TECHNICAL MEMORANDUM

Title: Technical Criteria Variance Application

Name: Hillside at Castle Rock

Number: TCV16-0048

OVERALL DETAIL DRAINAGE PLAN 1

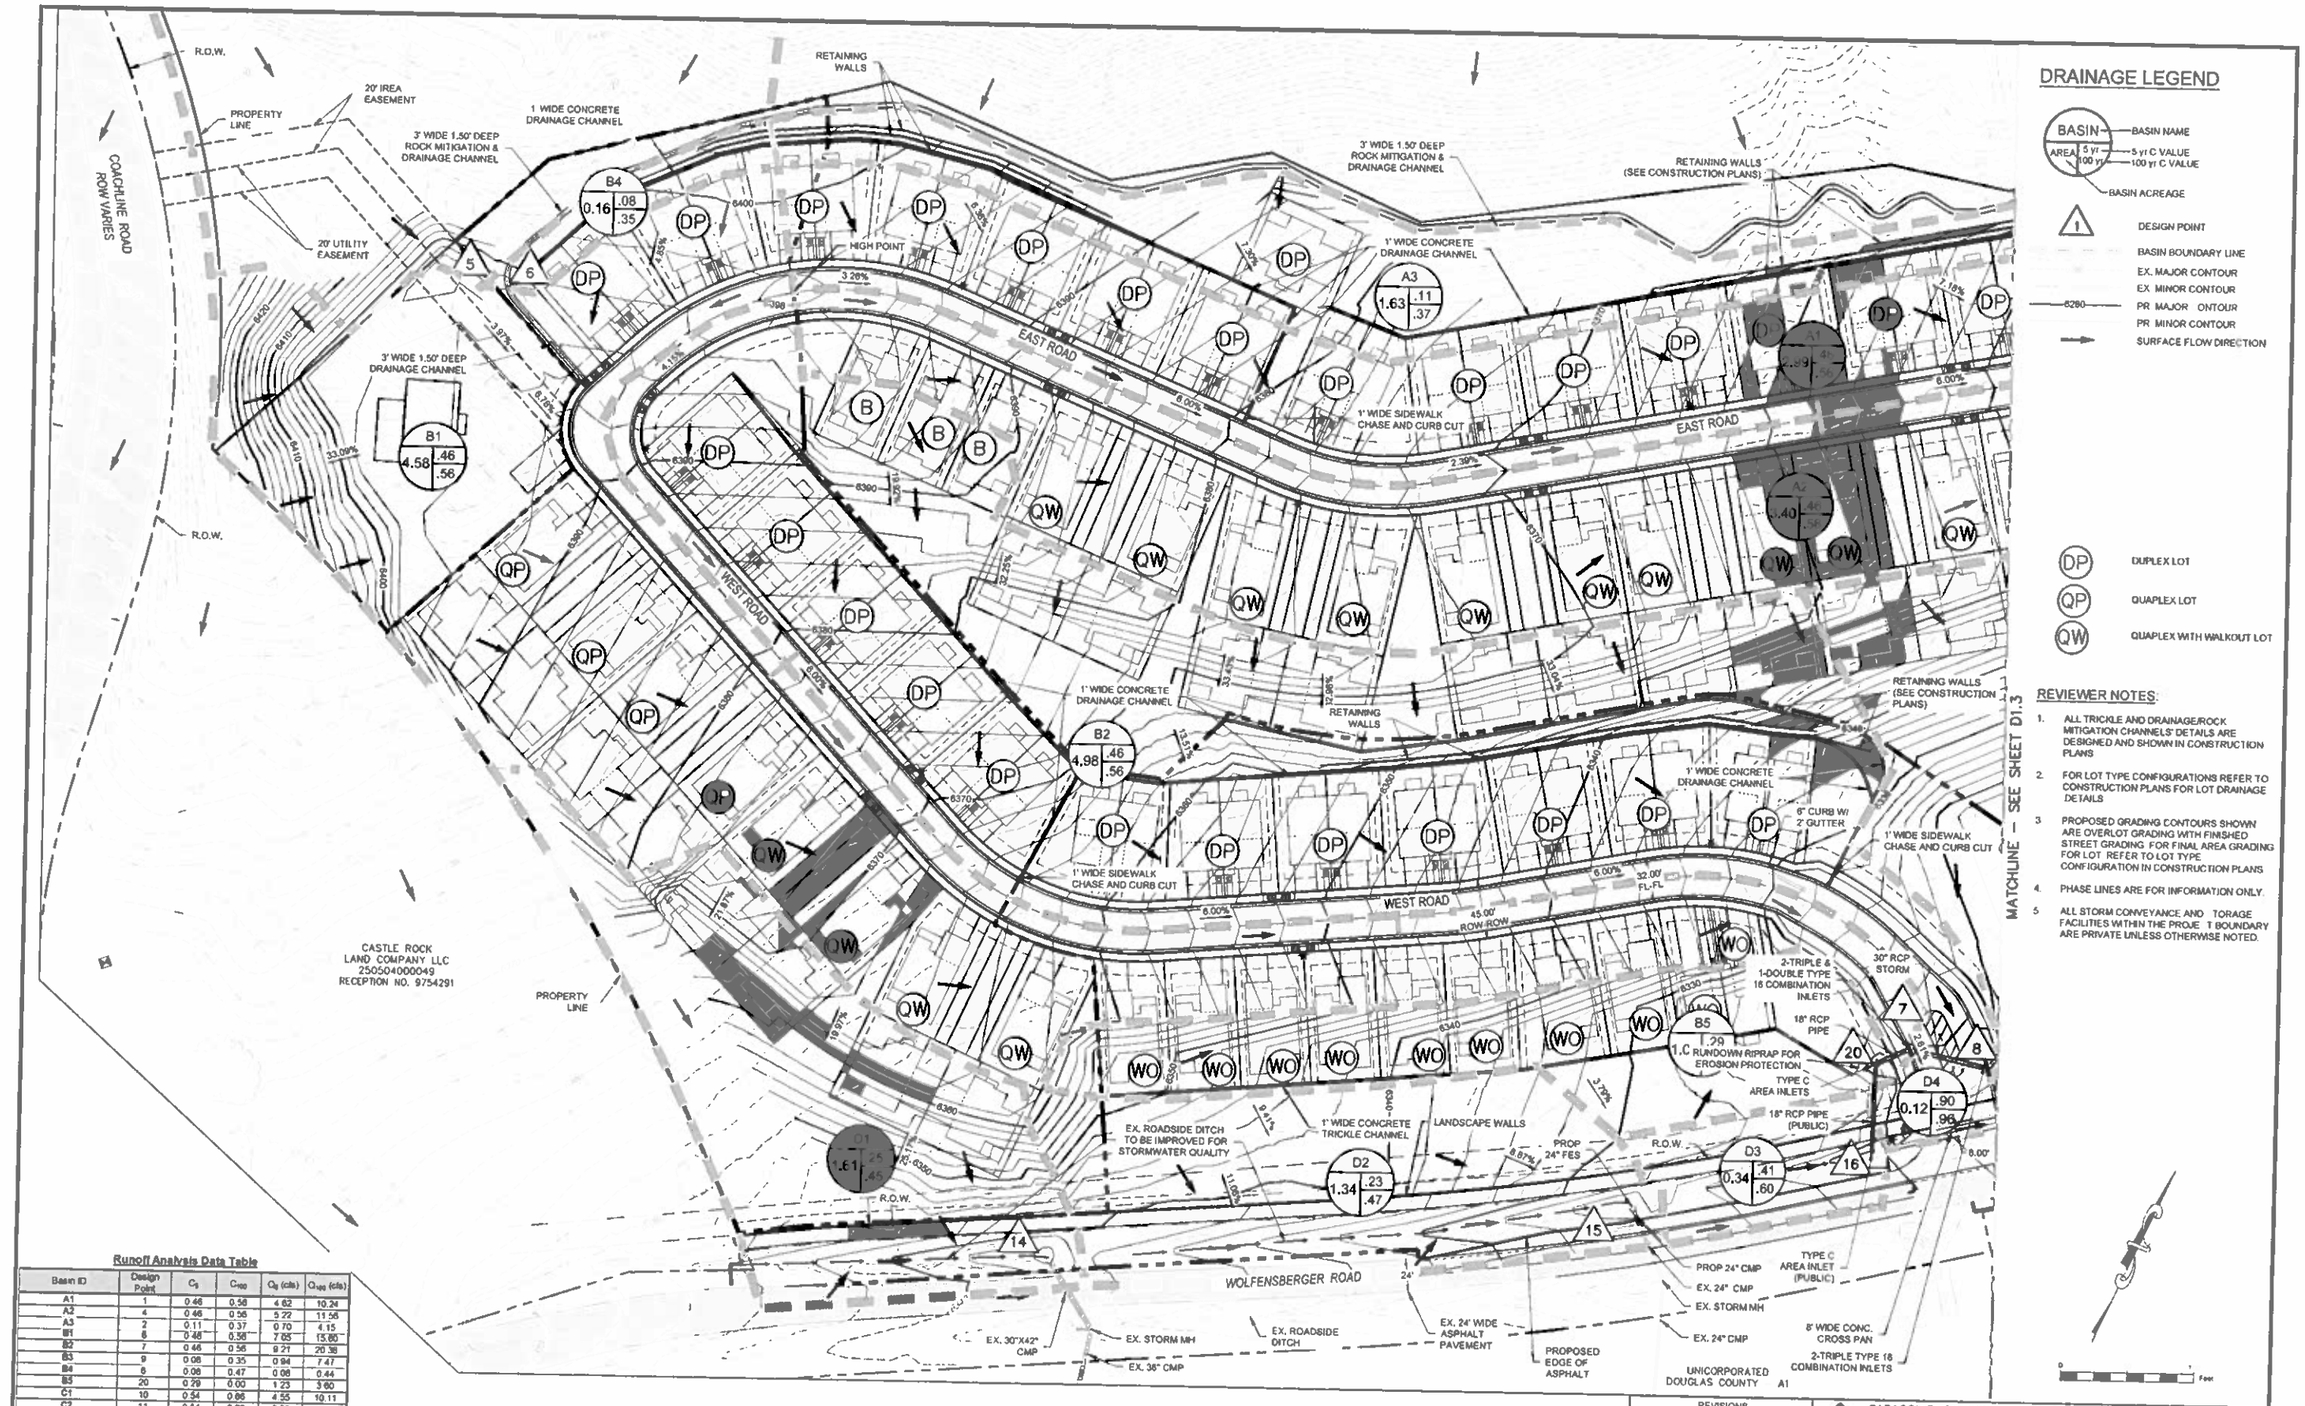
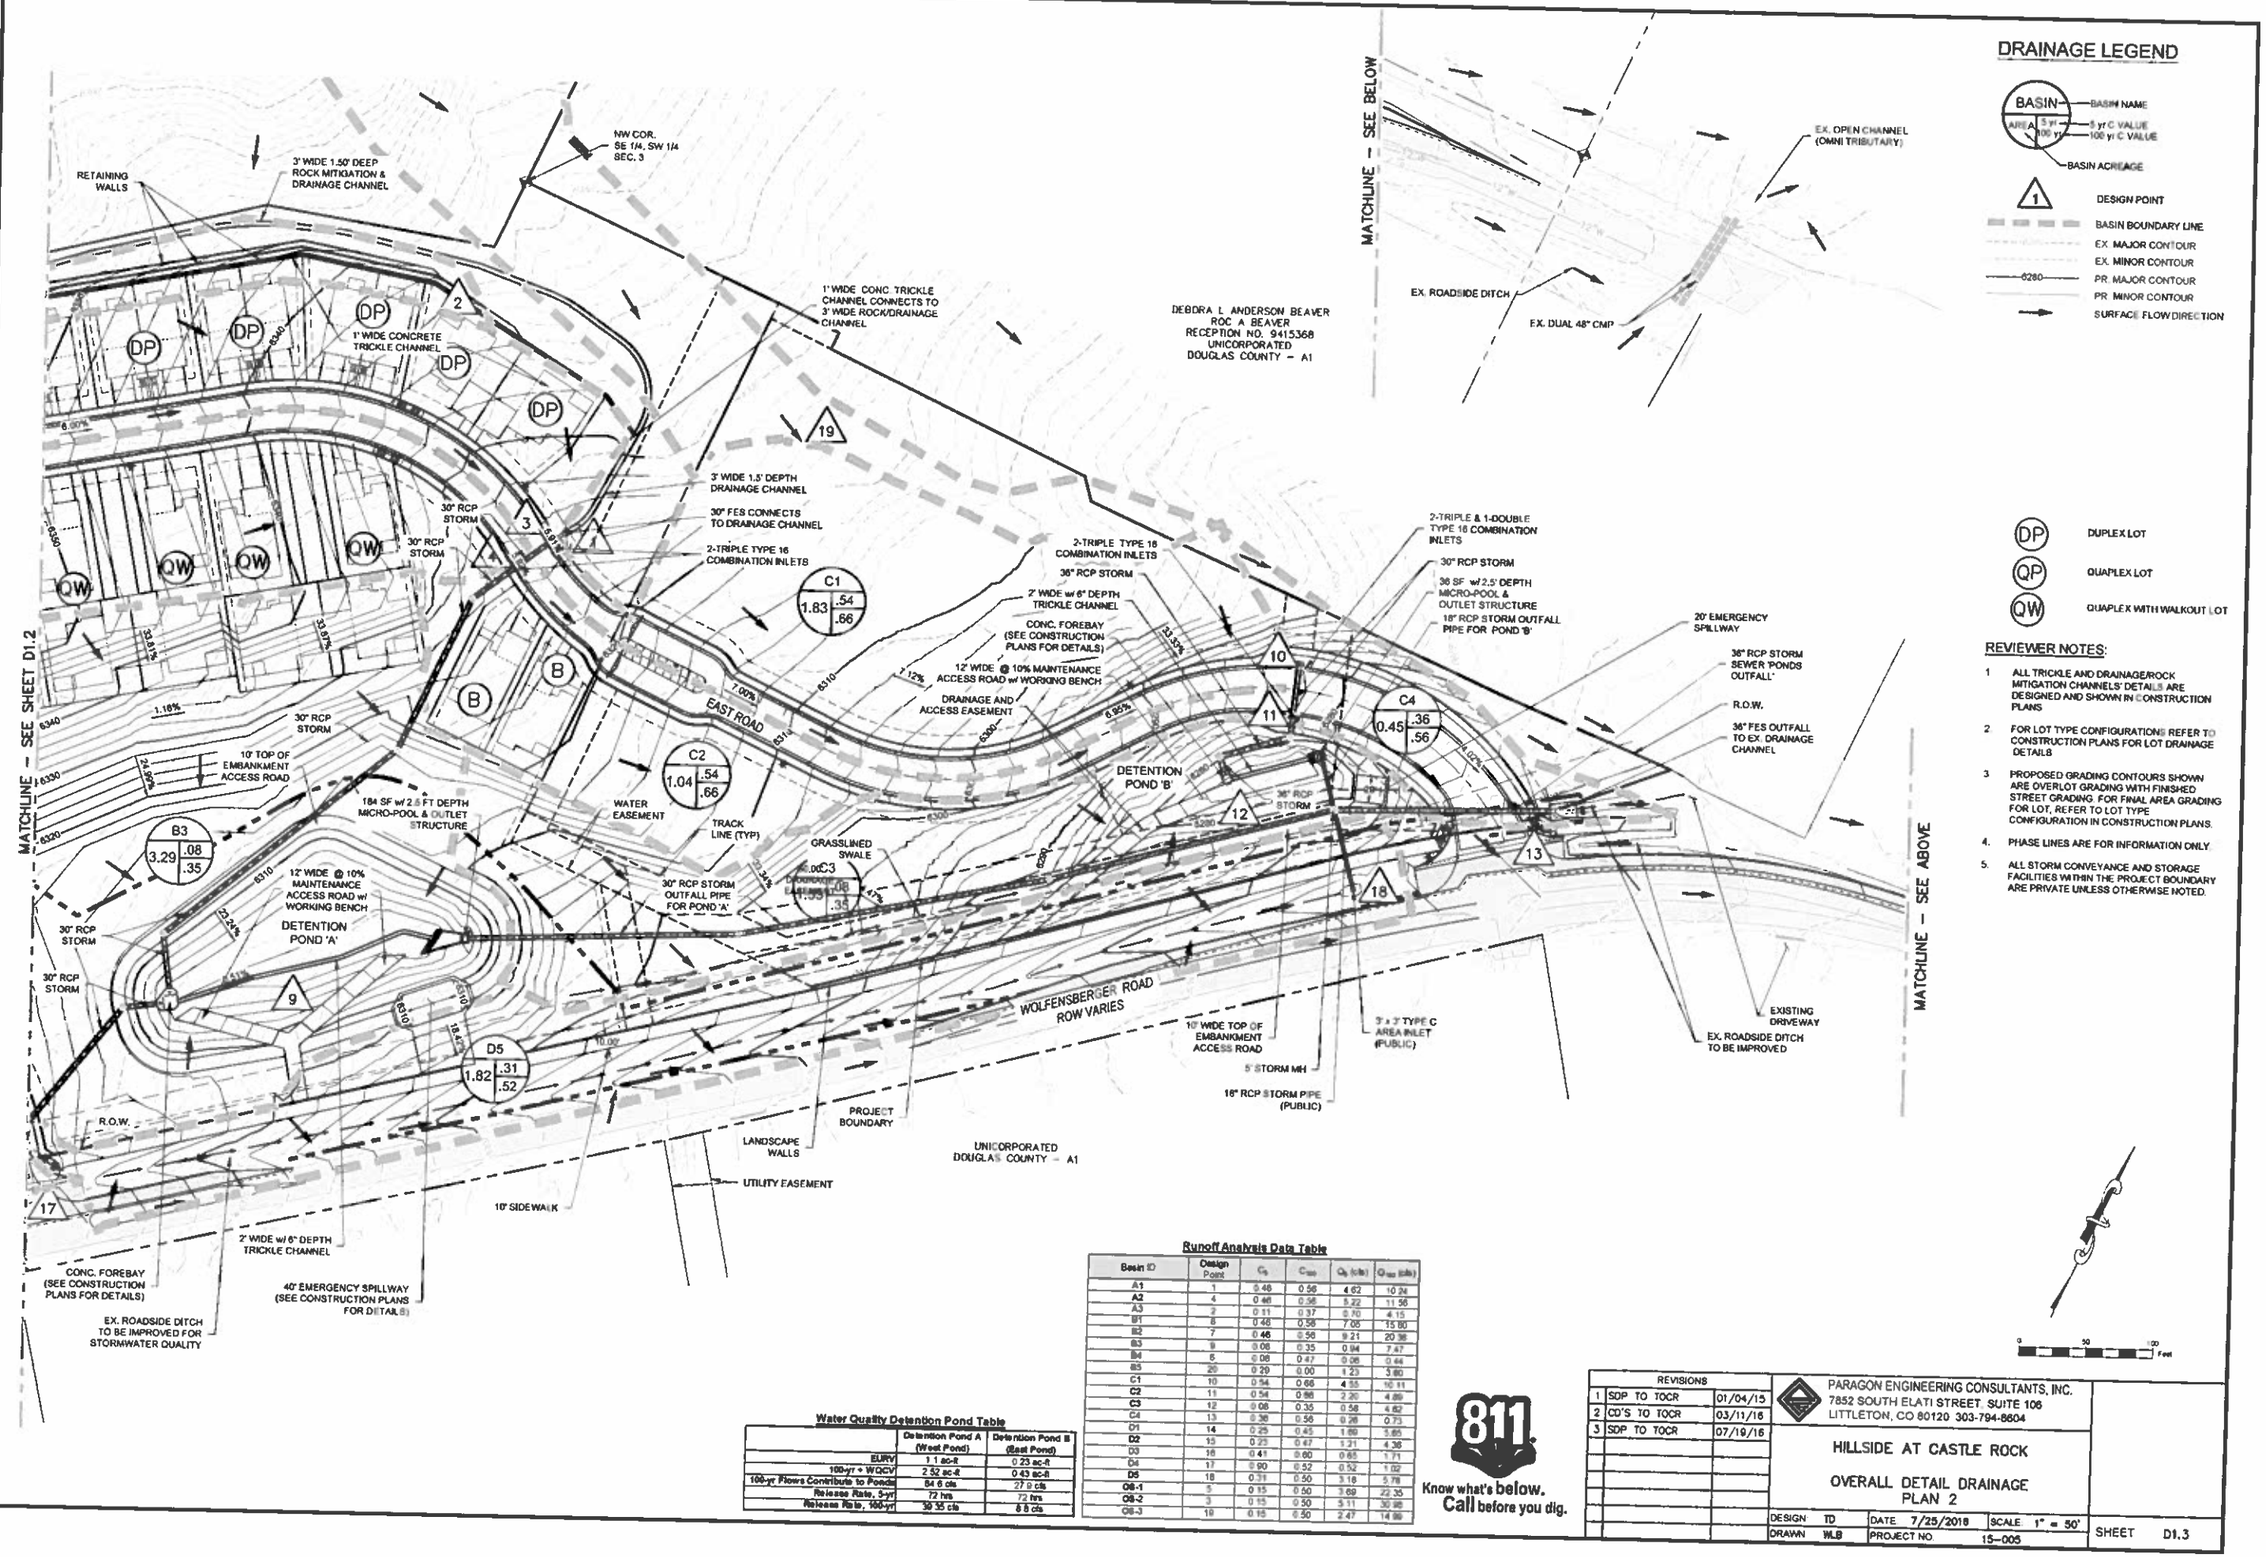
Describe the Variance Requested
A variance is requested from the implied requirement that 100% of the developed site area be routed through a water quality facility before exiting the site for Basin C4.

1. Describe the exceptional situation or condition that exists
Basin C4 is located at the SE edge of the site and is located downstream of the onsite detention/water quality facilities and is the lowest area of the site, therefore, it is not possible to route the runoff from Basin C4 through the onsite water quality ponds. See attached exhibit.

2. Describe the difficulty or hardship that would be created by a strict enforcement of the code
Since Basin C4 is: downstream of the onsite water quality facility; the lowest point on the site; runoff flows directly off the property into an existing roadside ditch.

3. Describe why there would not be any adverse impact on public health, safety and welfare
Basin C4 is 0.45 acres and the total developed acreage is 32.15. Basin C4 represents 1.4% of the total developed acreage.

Recommendation: ____X_____ **Approve** _____ **Deny**

A variance is requested to allow a maximum of 10% of the site runoff not be required to be routed through a water quality feature. Due to the configuration and grading of the site, there is an area at the southeast corner of the site where it is not feasible to route runoff to the onsite water quality facility or through grass lined swales.

The volume of runoff not receiving water quality treatment is minimal.
